**Public Input on General Electric's
Conceptual Design Plan for Rail Transload Areas in
Reaches 5 and 6, dated February 20, 2026**

Re: **GE-Pittsfield/Housatonic River Site
Conceptual Design Plan for Rail Transload Areas in Reaches 5 and 6**

Technical Assistance Services *for* Communities GE-Pittsfield/Housatonic River Site Comments on Conceptual Design Plan for Rail Transload Areas in Reaches 5 and 6 February 2026

**Technical Assistance Services for Communities (TASC)
Comments on Conceptual Design Plan for Rail Transload Areas in Reaches 5 and 6
February 2026**

Figure 2: Conceptual Design for Utility Drive Transload Area

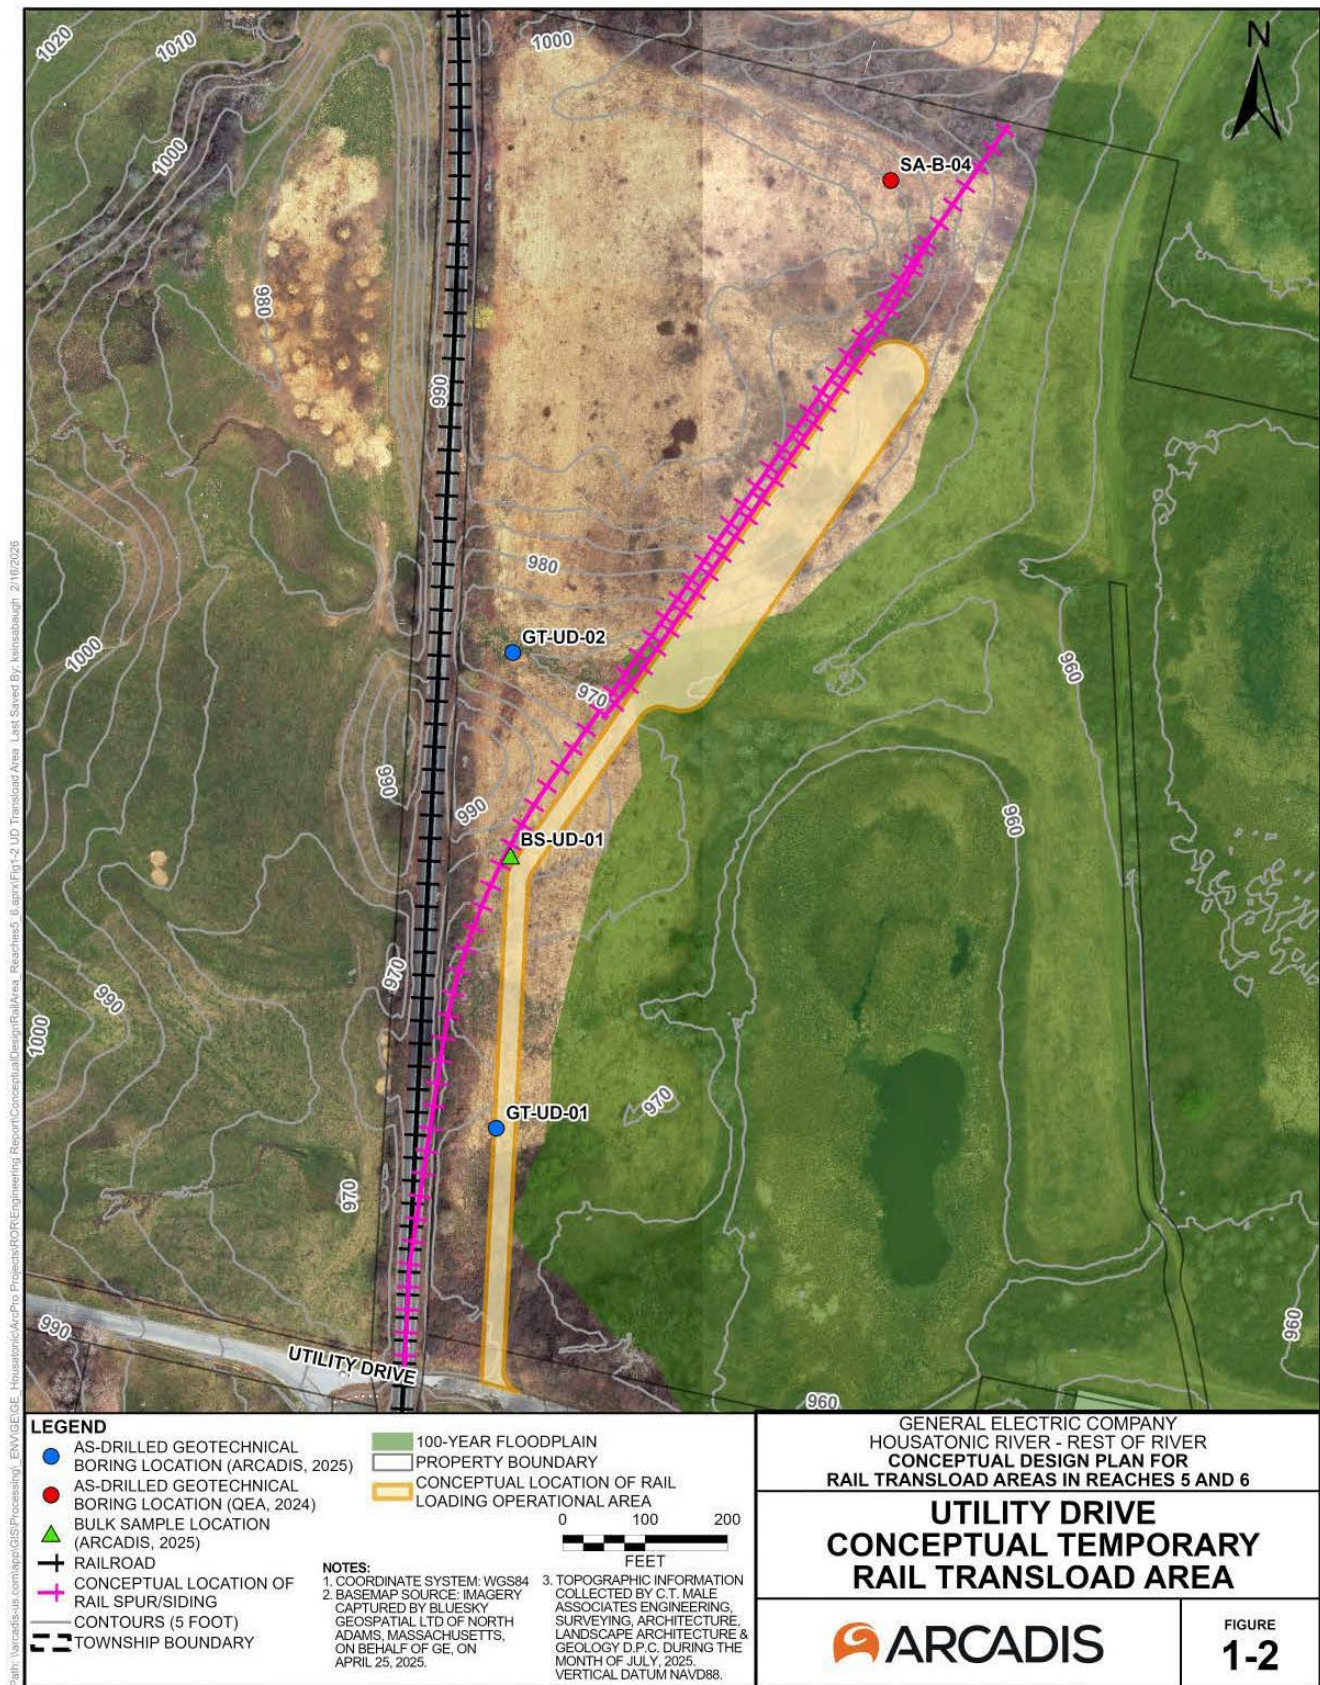
5. Section 4.2 describes the site preparation and stormwater management approaches for the rail transload construction. As stated within the document, “A significant amount of earthwork will be required to create a level and usable area for the Utility Drive rail transload area, with both cut and fill activities anticipated across portions of the site.” The scope of earthwork for the Utility Drive rail transload area raises several questions:

- It is not clear if there is enough surface area within this transload area to provide storage for stockpiled surface soil, managed storage containers, transload traffic and transload operations.

- The proposed construction footprint will add impermeable surfaces that will affect stormwater pathways and volumes. It is not clear if the existing culverts are sized appropriately to manage the existing baseline flows and any anticipated additional stormwater flows.

- The document acknowledges that portions of the access road and supporting/loading area are within the footprint of the 100-year floodplain defined by the Federal Emergency Management Agency (FEMA), and therefore these areas are elevated to

address flood concern. However, the potential flooding attributable to climate change is not mentioned.

The community may want to ask EPA if the surface area within the Utility Drive rail transload area is sufficient to accommodate all the area activities, if the existing stormwater features are sufficient to address combined stormwater flows in the future and if the design addresses potential flooding-related impacts.

Figure 3: Conceptual Design for Woods Pond Spur Transload Area

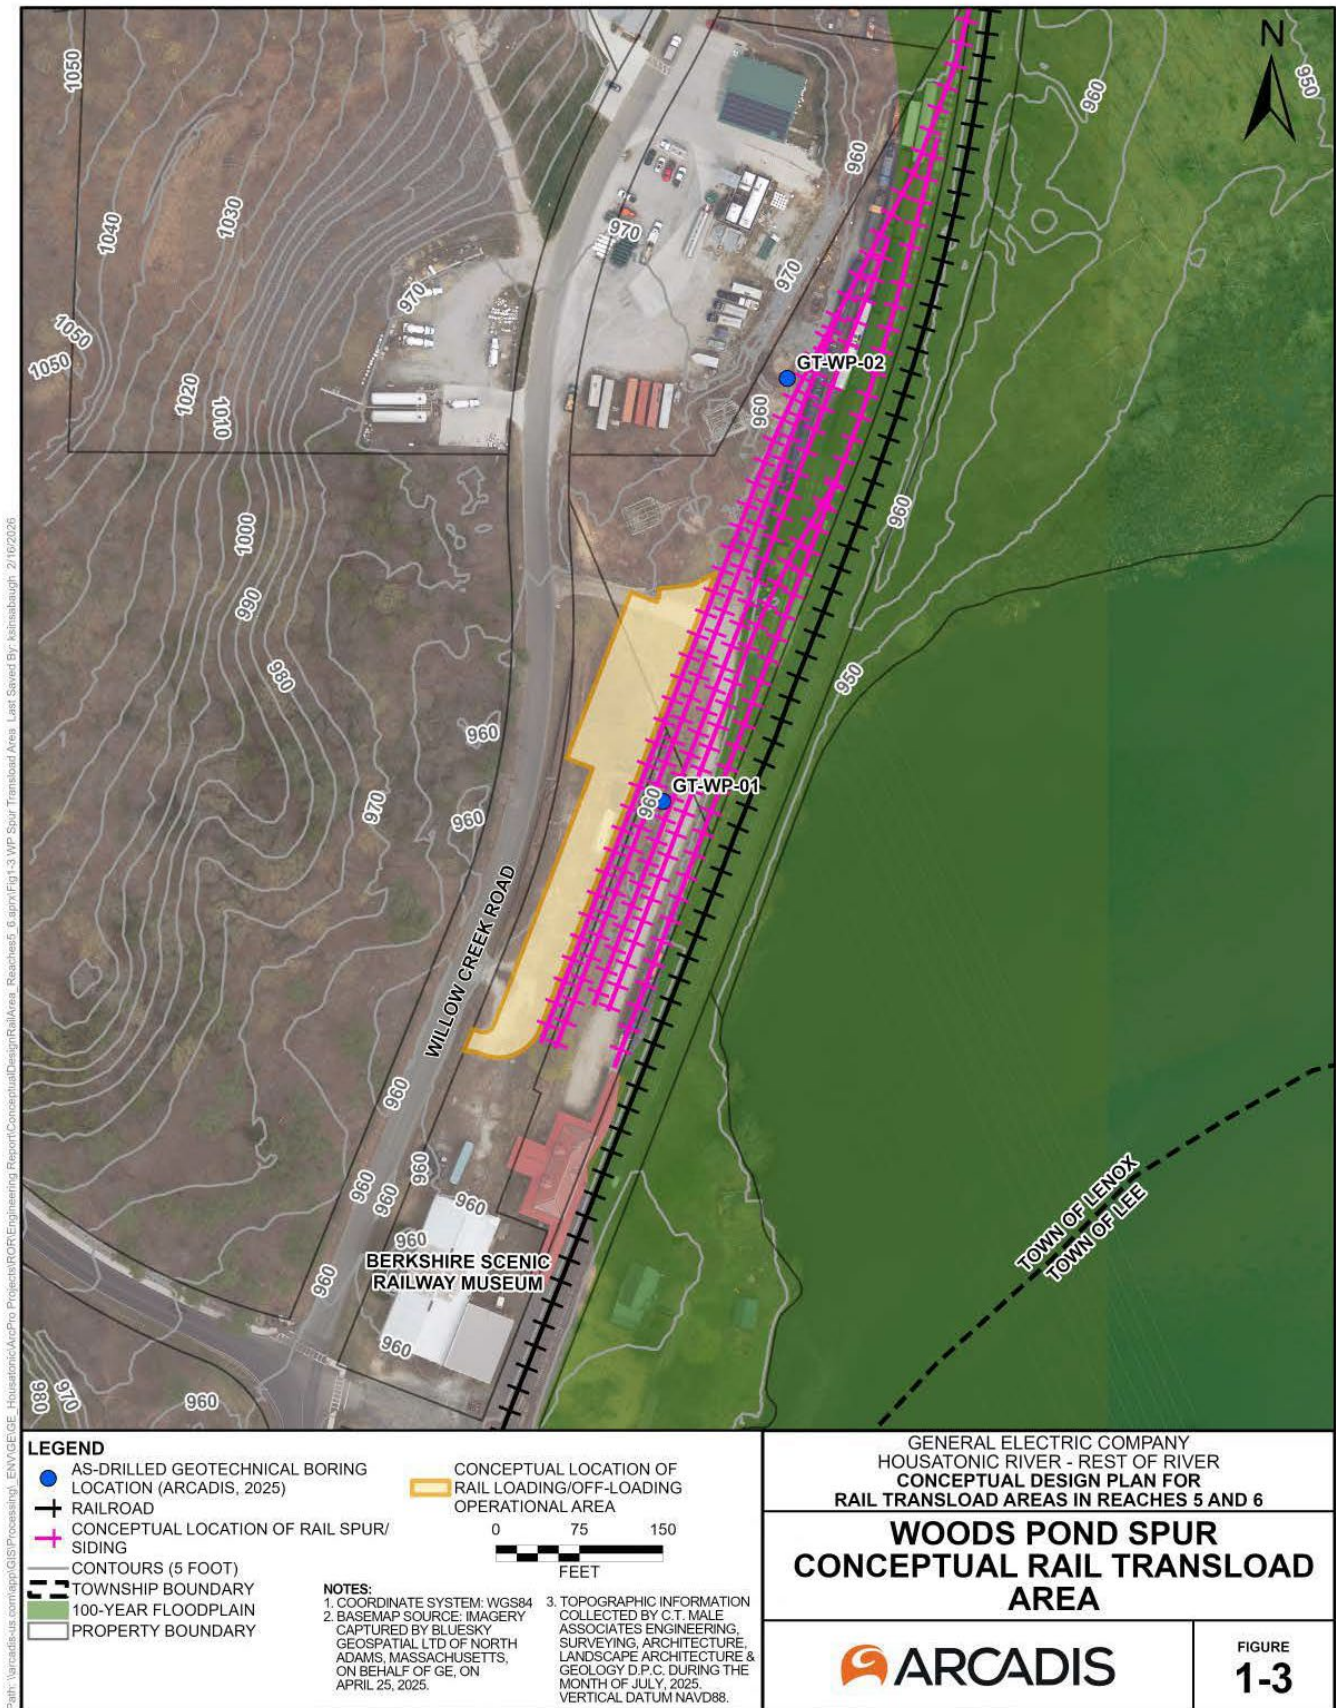
21. Figure 3 above (Figure 1-3 in the document) shows a pink highlighted near the Berkshire Scenic Railway Museum. However, this feature is not defined in the legend. Furthermore, the figure shows the conceptual location of the rail spur/siding. The scale of the rail makes the lines appear to overlap. It may be useful to adjust the scale of these features.

The community may want to ask EPA if Figure 1-3 can be amended to define the feature associated with the museum and to provide scale to the overlapping rail lines.

Figure 4: Cropped Figure 4-6 Pilot Study Vernal Pools: Test Pools (5A-VP-52; 5A-VP-57); Control Pool (5A-VP-55) Vernal Pool Pilot Study Work Plan Housatonic River – Rest of River (pdf page 59 Anchor QEA, 2023). These pools are immediately to the East of the Utility Drive rail transload area.

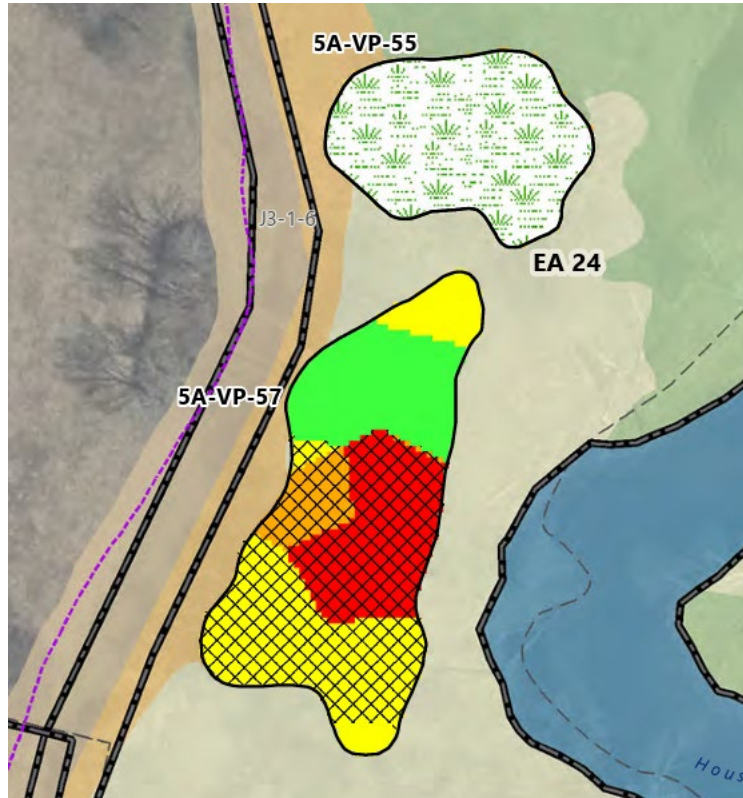
11. In regard to vernal pools, the document states, “An evaluation was conducted for the possible presence of vernal pools at both rail transload properties. This evaluation was performed as part of an overall evaluation of potential vernal pools in the Reach 5A floodplain in 2018 and 2019, which included an inspection of wetland areas using procedures employed by the Massachusetts Natural Heritage and Endangered Species Program (MNHESP) for determining whether a pool meets the criteria for a certified vernal pool (AECOM 2020). No potential vernal pools were identified at either the Utility Drive property or the Woods Pond Spur property.” However, it seems important to note that there are several vernal pools immediately adjacent to the Utility Drive rail transload area (Figure 4). While there may not be any vernal pools within the area itself, it seems important to understand the implication of earthwork impacts to the adjacent pools. Of particular concern may be the impacts from construction to the groundwater levels, which could be hydrologically linked to the pools.

The community may want to ask EPA if there is any potential impact to adjacent vernal pools associated with the Utility Drive rail transload area due to construction impacts to groundwater.
